Project	Greville Street
Title	Technical Note for Planning Response
Ref.	248
Rev.	A
Date	04.10.19

The purpose of this Technical Note is to provide technical guidance regarding a minor material change to the consented scheme (Planning Ref. 2019/3565/P) to provide a stepped colonnade whilst retaining DDA access.

Ground floor plan (248_501_Rev0) showing assumed level access from Bleeding Heart Yard into the development.

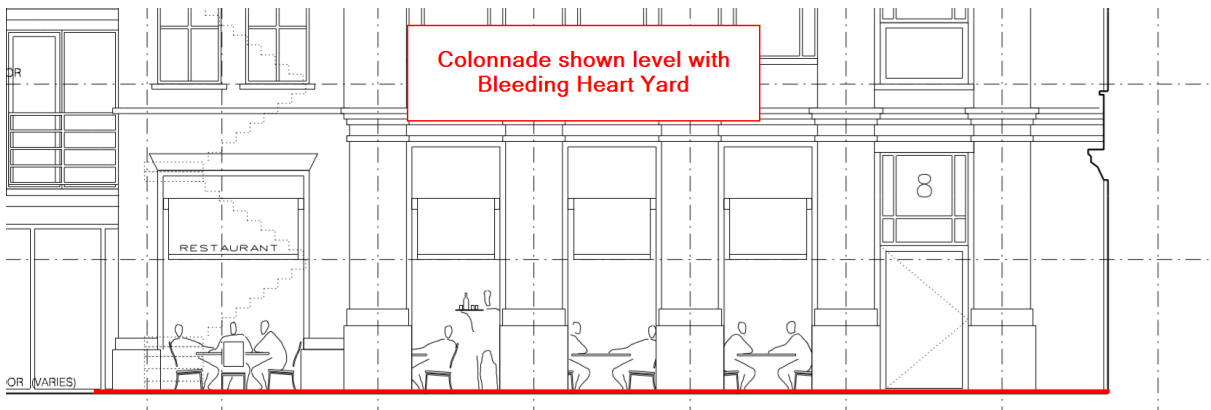
The proposals assumed Bleeding Heart Yard and the ground floor level of 20-23 Greville Street were at a similar level, offering simple DDA access from the public realm into the building without increasing internal floor finish levels and thus decreasing floor to ceiling heights to usable areas.

Elevation C from Matrix Surveys' measured survey (10.07.19) showing difference of between 750-320mm in external and internal floor level in Bleeding Heart Yard.

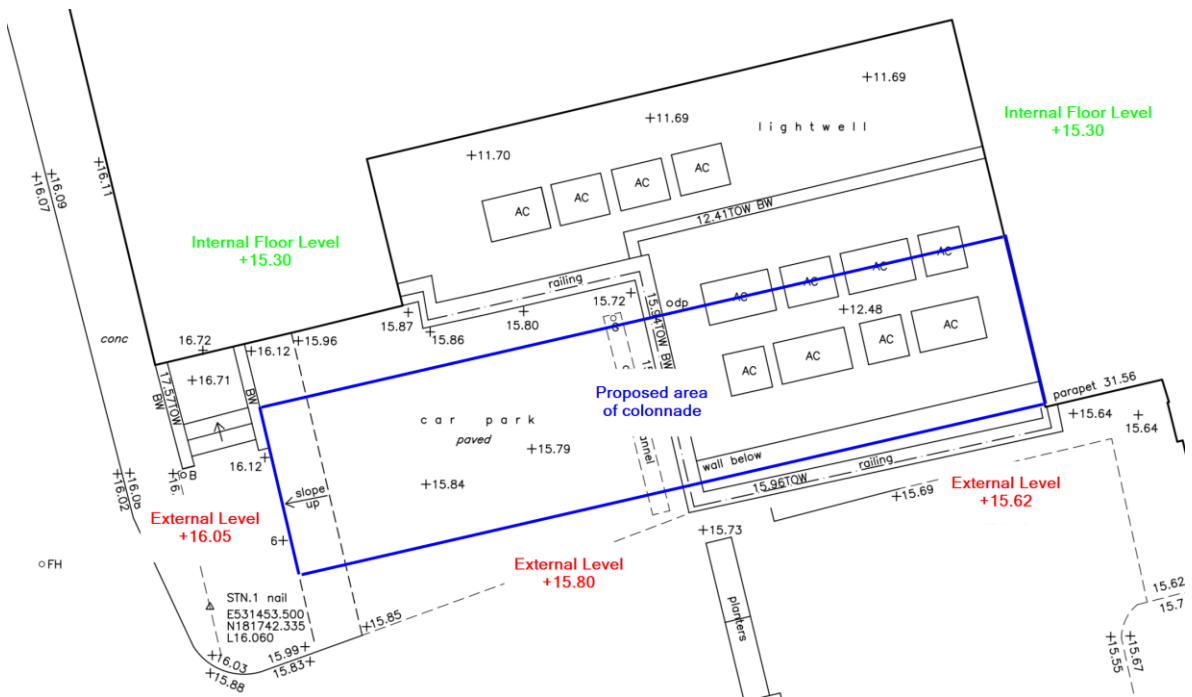
The below plan and elevation are extracted from a measured internal and topographical survey undertaken by Matrix Surveys on 10th July 2019. The key differences from the assumed levels at planning and the actual are significant, giving rise to a difference in between 750-320mm.

The above images highlight the difference in floor level if step-free access is to be offered from Bleeding Heart Yard into the development, importantly making it unviable – explored below.

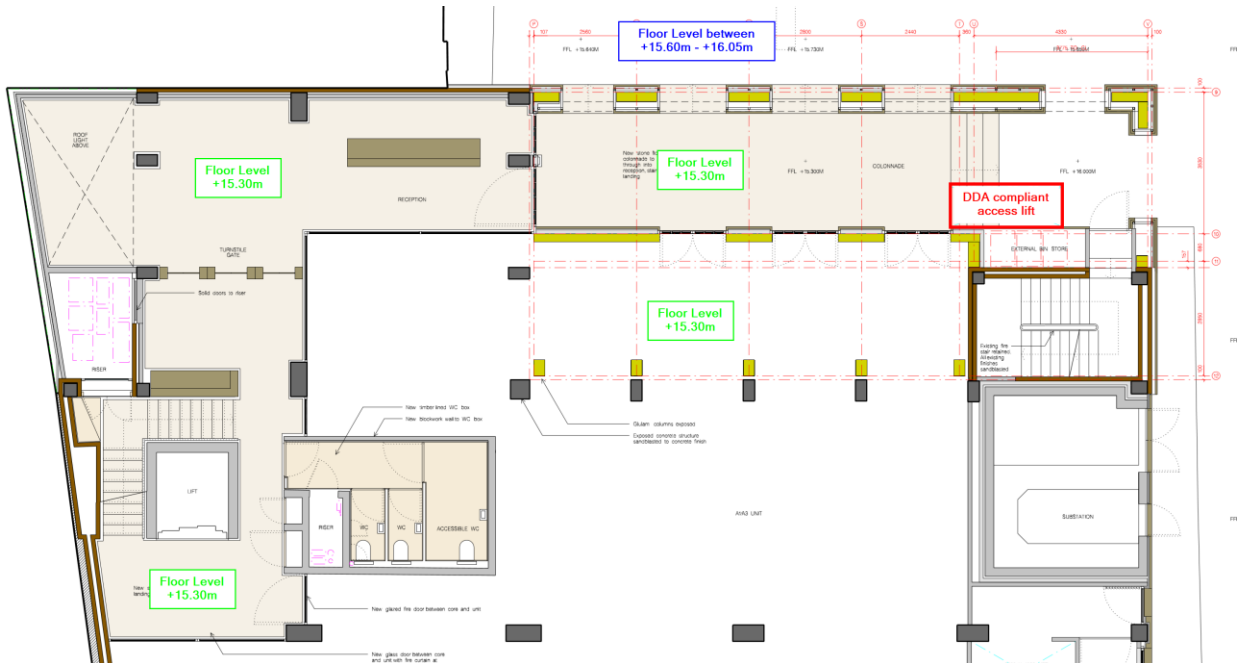
If the planning approved level access were to be implemented, the following issues would arise:

- DDA access to ground floor – an increase in the ground floor level by 320mm would remove level access from Greville Street into the commercial fronting unit, contradicting the planning approved proposals to reintegrate the building with its street frontage.

- Floor to ceiling heights – all reception areas would be reduced to 2.38m (from 2.7m) under slab and crucially 2.08m (from 2.4m) under beam. This is clearly in disagreement with Camden's design standards to ensure floor to ceilings achieve 2.5m throughout. Furthermore, this creates limitations in the suitability of A1/A3 area for potential tenants which would be considered to oppose Camden's desire for new commercial floorspace.

- Stepped access to basement level – the increase of the ground floor level by 320mm would necessitate an additional 2 stairs from basement level into the reception area. Decreasing this exit route by 500mm (2x250mm steps) to 750mm would make the remaining passing space unable to satisfy Regulations. Furthermore, as 1 of 2 fire exits, this route must be kept to the maximum width possible to satisfy Regulations and standards accepted by LFB.

- Ramped access – adding ramped access into the colonnade area would limit significantly the ability to offer practicable level seating to the ground floor A1/A3 unit, decreasing from the scheme's original objective of allowing an extension of the public realm in Bleeding Heart Yard to extend into the new colonnade.

Proposed ground floor plan showing floor levels at reception, ground and colonnade areas and location of DDA lift.

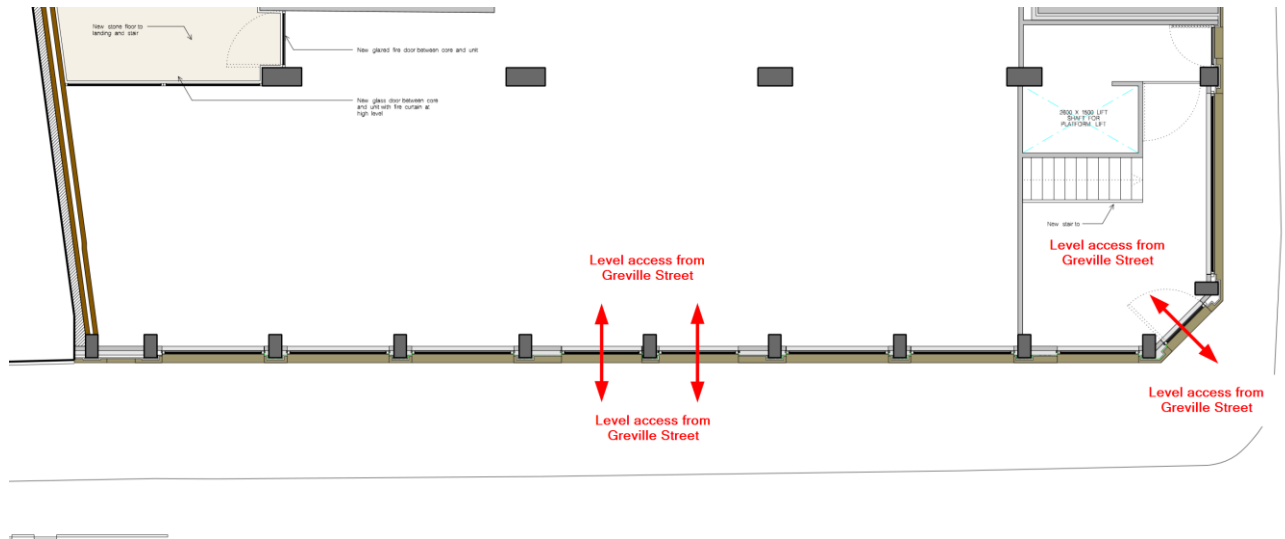
The applicant wishes to significantly improve the existing building's current access arrangements by adding DDA access into the new reception area off Bleeding Heart Yard. The DDA access is offered via a retractable lift travelling 750mm from street to colonnade level.
